INSPECTION REPORT
Sedimentation Structure
WW-2
Kayenta Mine
Navajo County, Arizona
for
PEABODY COAL COMPANY

Dames & Moore
10139-011-22

SITE PLAN
WW-2

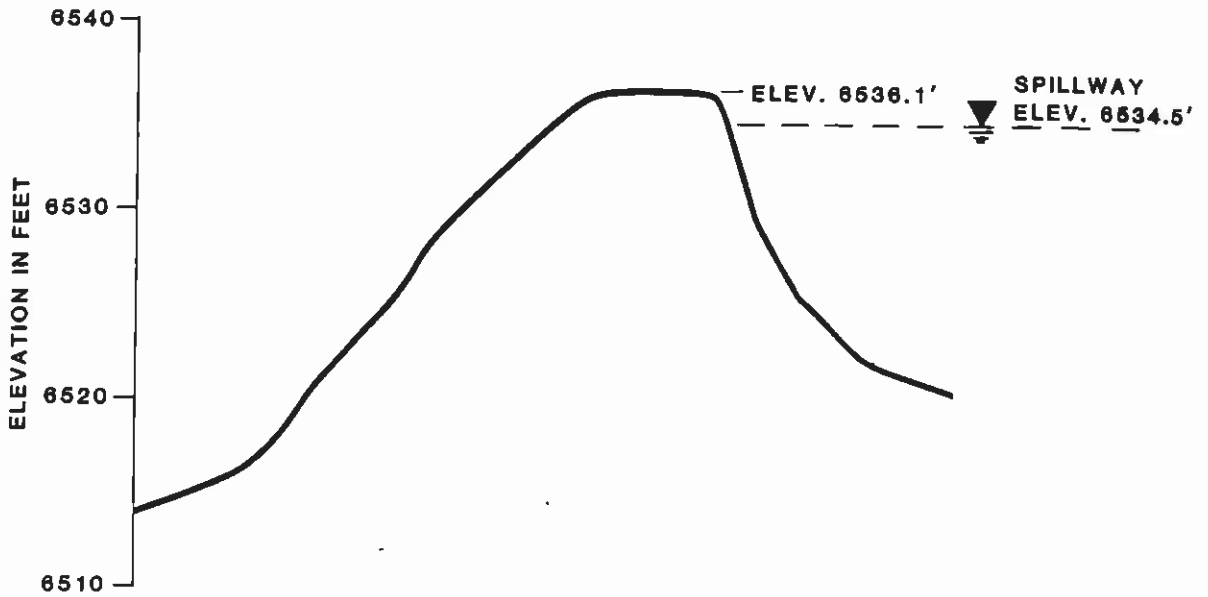
The storage capacity and spillway capacity of Structure WW-2 are adequate; however, the spillway does not have an adequate outflow channel or adequate erosion protection. A trapezoidal outflow channel should be constructed along the alignment B-B' shown in Plate 1. The channel profile is shown in Plate 4 and the required dimensions are shown in Plate 5. Both the spillway and outflow channel should be protected against erosion using geotextile and gravel as shown in Plate 5.

EXISTING
MAXIMUM CROSS-SECTION
A-A'
WW-2

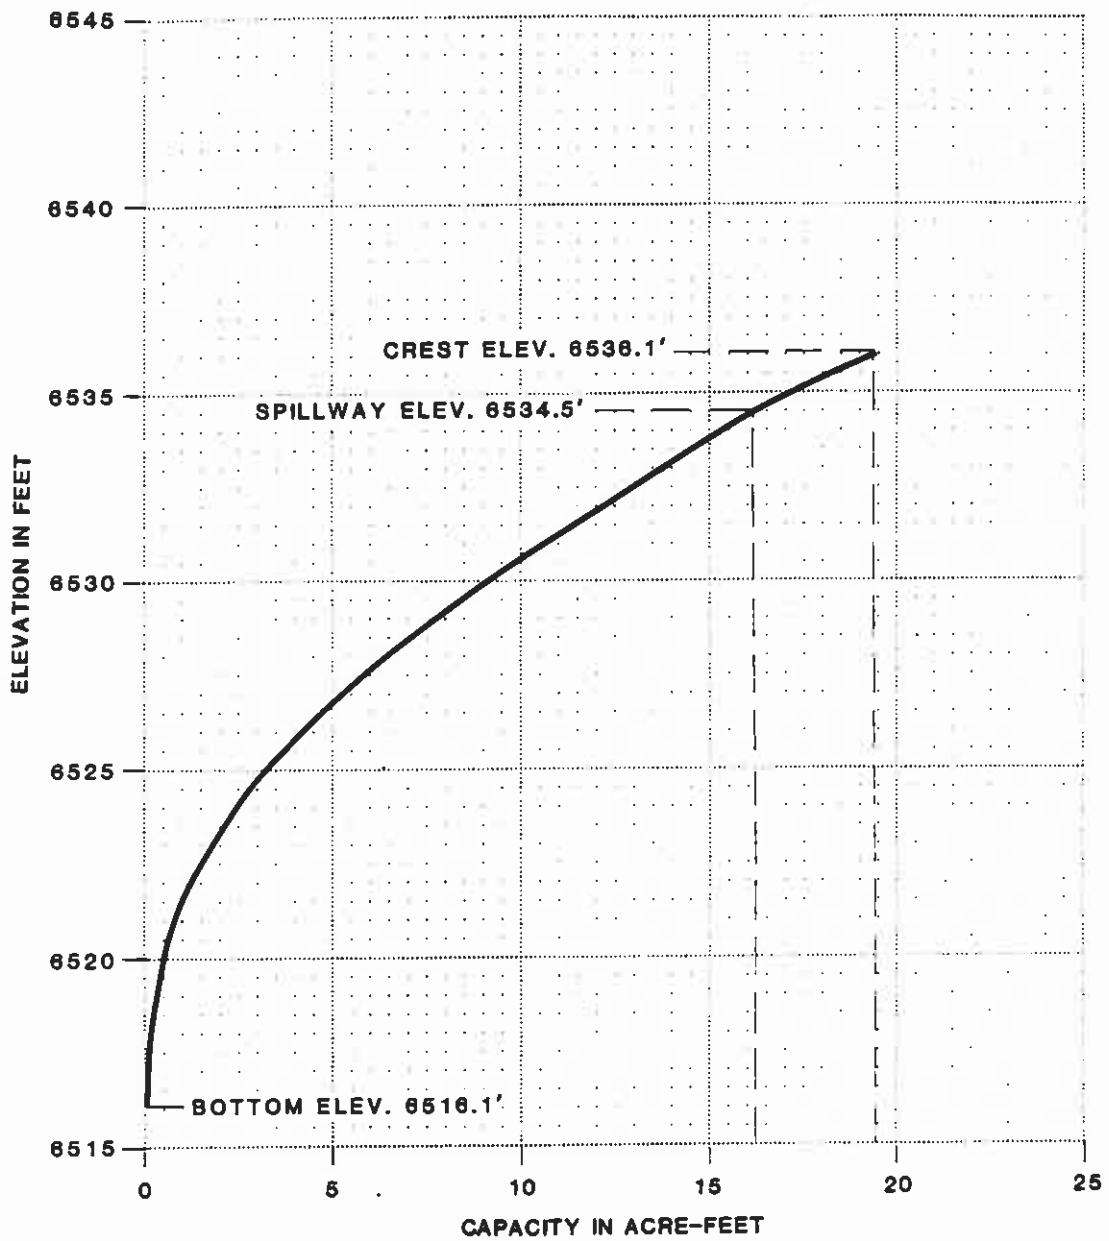
The WW-2 embankment is lower in height; however, the downstream slope is steeper than the category standard; therefore, the embankment has factors of safety less than the design minimum.

require remedial action. The downstream slope should be flattened to 4.0 horizontal to 1 vertical to meet stability requirements.
